CONNECTICUT YANKEE ATOMIC POWER COMPANY

Haddam Neck Plant
Systematic Evaluation Program Integrated Assessment

Systematic Evaluation Program Integrated Assessment

Resolution of Open Issues

NORTHWEST UTILITIES SERVICE COMPANY
 CONNECTICUT VEHICLE SERVICE BLDG
 APPENDIX "R" STUDY
 SHEET 0605822

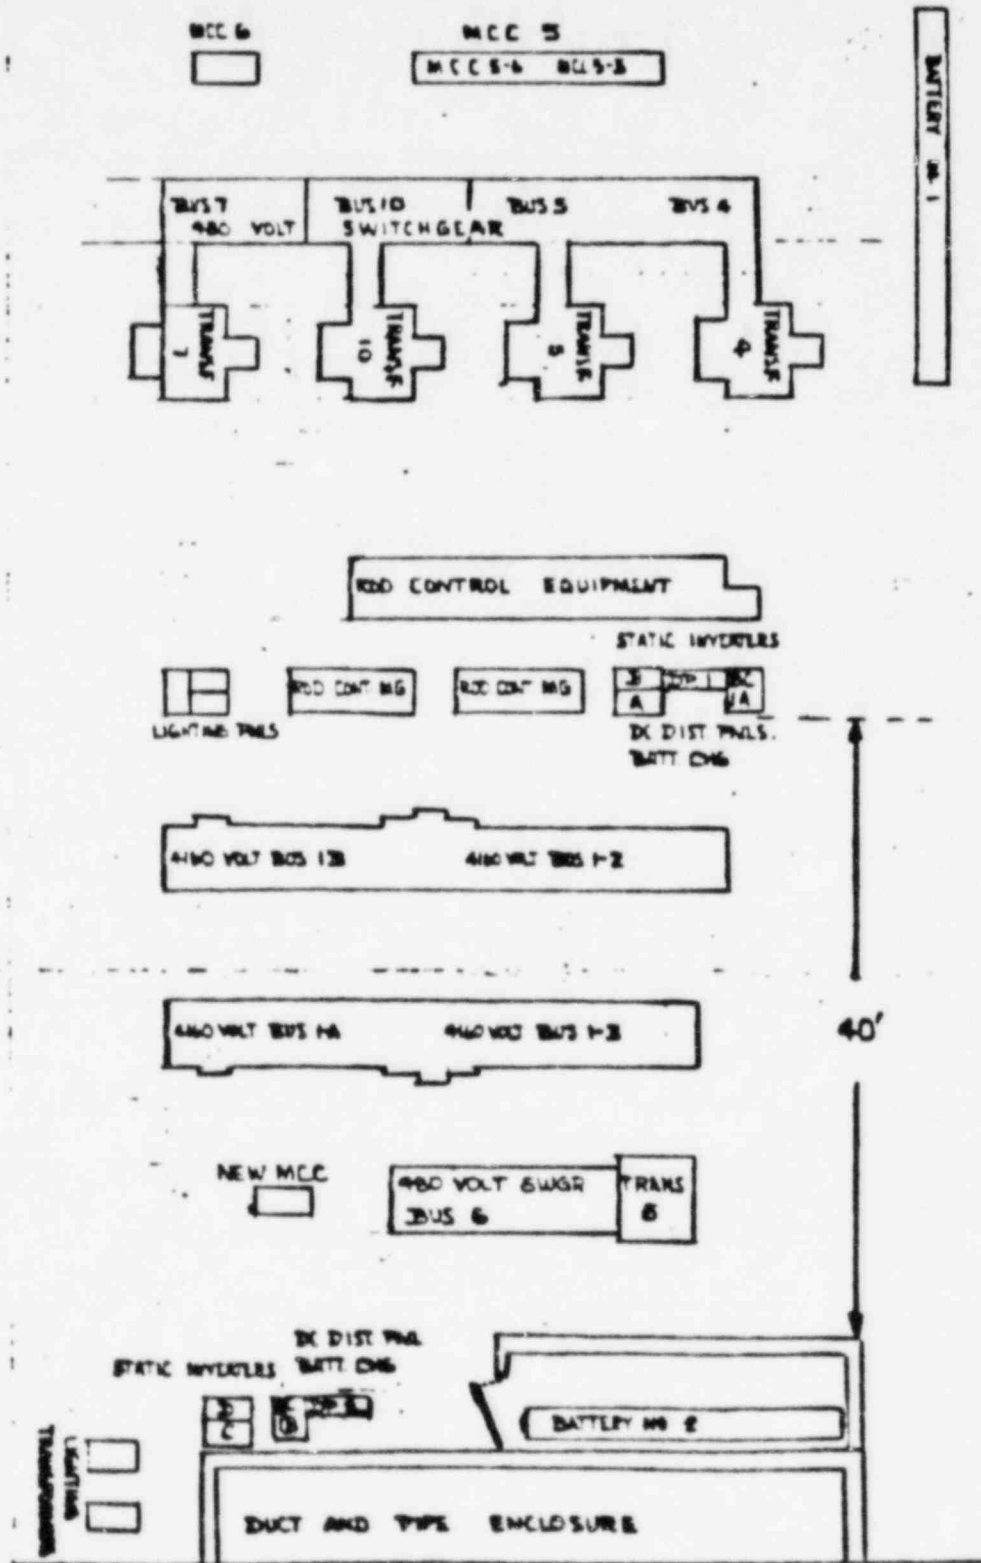
Additionally, it should be noted that as part of the modifications planned as a result of the Appendix R Fire Protection Review, CYAPCO has proposed to relocate one battery set, two inverters, an essential 480 volt bus and transformer, and install a new motor control center in the south end of the switchgear room. This will provide a minimum of 40 feet of separation between the redundant shutdown trains. Completion of these modifications will eliminate the dependancy on MCC-5 for safe shutdown and also provide assurance that both shutdown divisions could not be disabled by an internally generated missile. Further information on the intended modifications can be found in a letter from W. G. Counsil to D. G. Eisenhut dated July 16, 1982. A sketch of the configuration of the switchgear room following completion of the proposed modifications is attached.

MCC 5 CAN RECEIVE POWER FROM EITHER DIVISION A OR DIVISION B THEREFORE IT IS COLORED YELLOW. AFTER THE PROPOSED MODIFICATIONS ONLY DIVISION A (RLD) SAFE SHUTDOWN LOADS WILL BE POWERED FROM MCC 5.

PRESENT DC BUS / VITAL AC BUS ARRANGEMENT

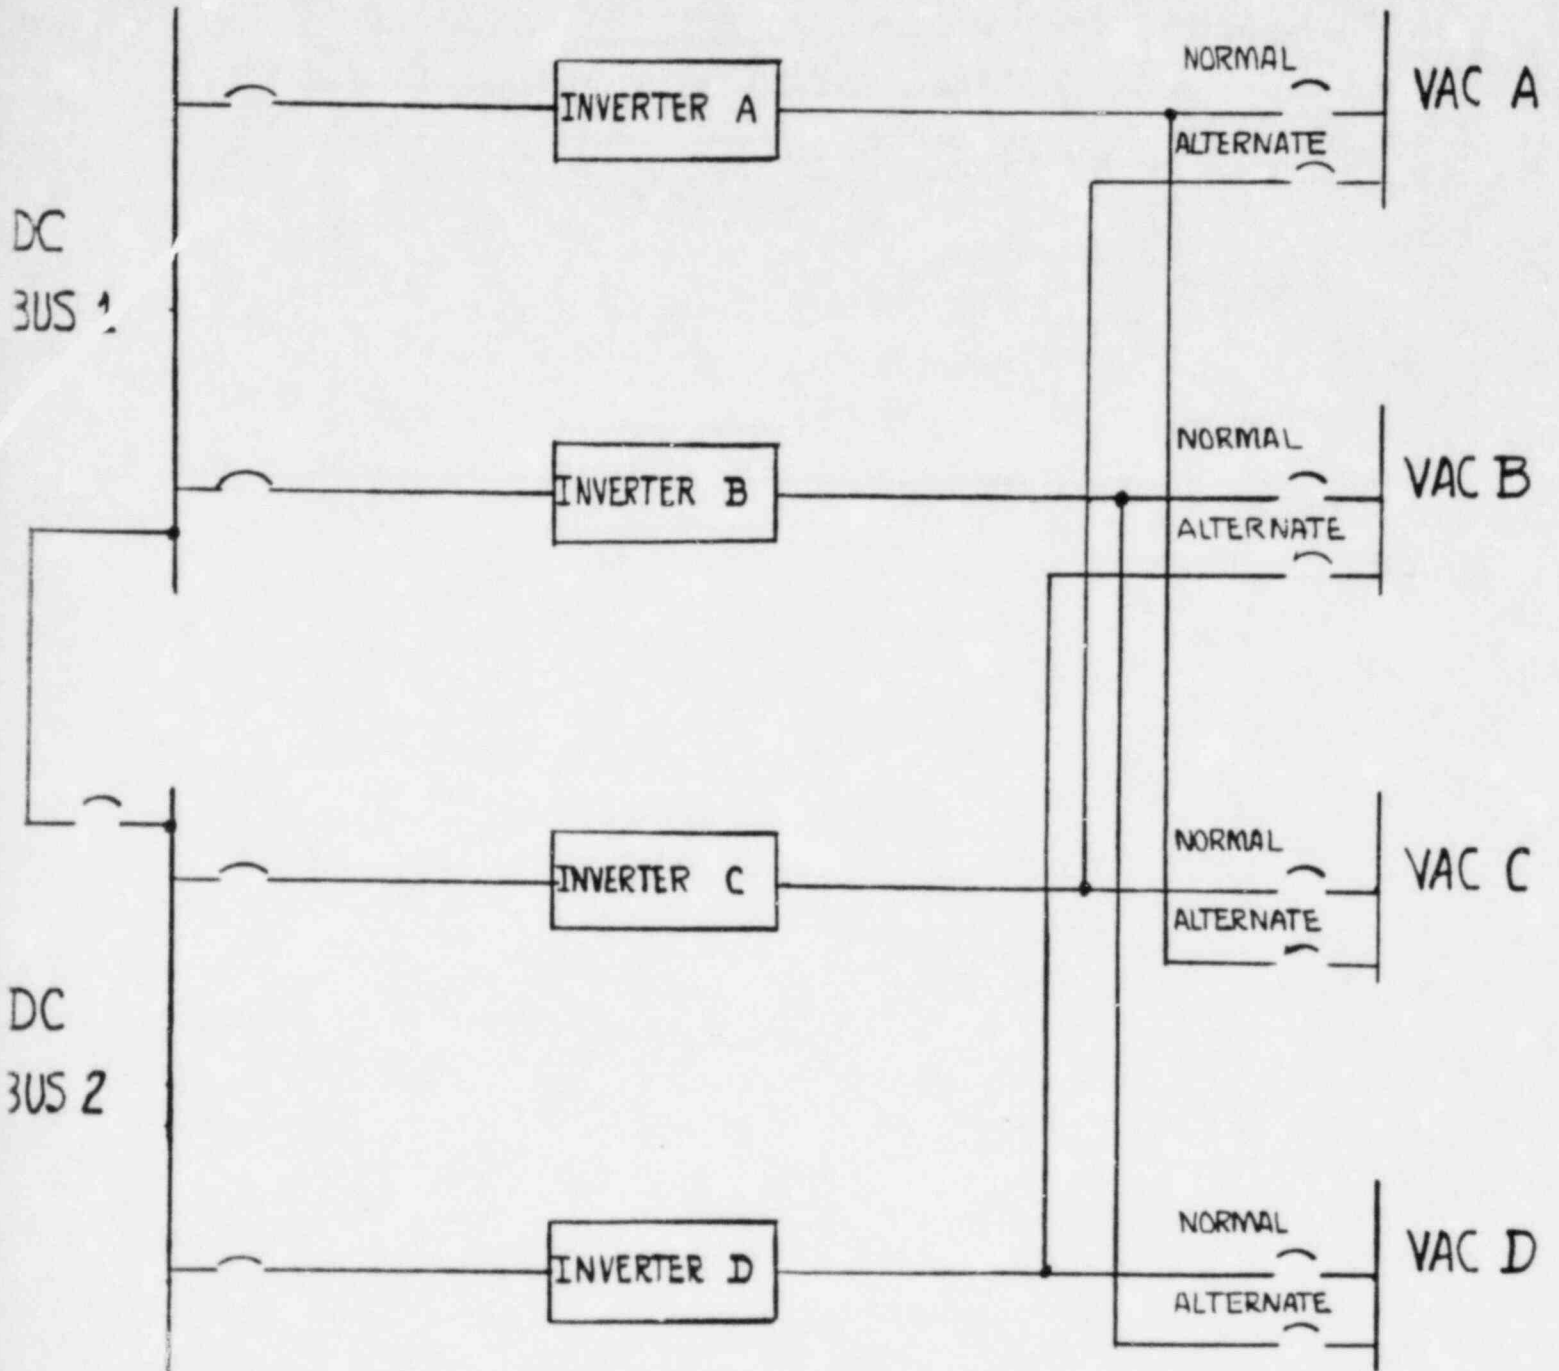
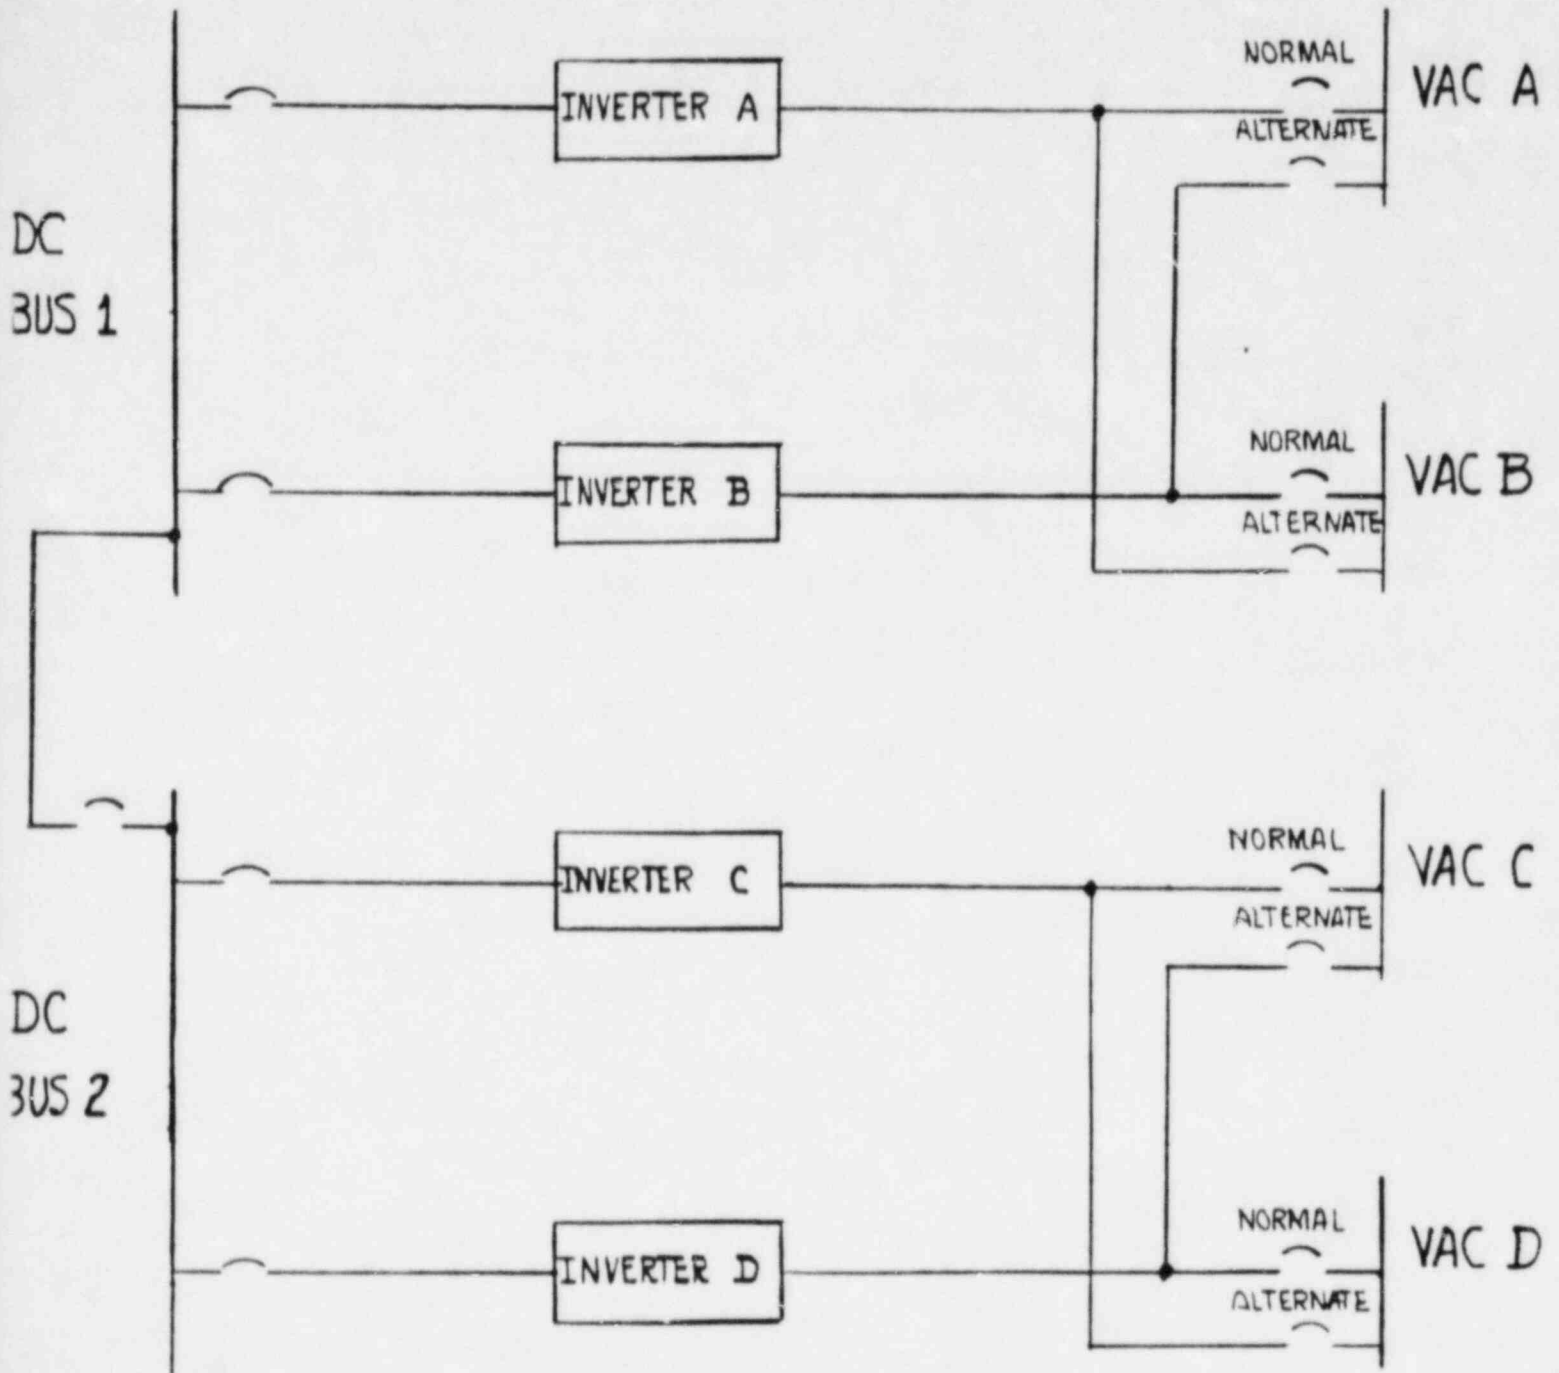
The Haddam Neck onsite standby AC and DC power systems do not comply with current licensing criteria. In each case, a manual breaker exists which allows paralleling of the two power divisions; no interlocks or procedures prevent this. Additionally, the DC power system design permits all four inverters to be supplied from a single battery.

The manual tie breakers in the AC power system and the DC power system (between DC Bus 1 and DC Bus 2) will be administratively controlled to prevent an operator error which would parallel the two power divisions.

All four inverters can be powered from one battery only by tying the two DC buses together and removing one battery from service. This not only powers all four inverters from one battery but is also powers the entire DC system, both divisions, from one battery. As discussed above, this will be administratively controlled during power operation.
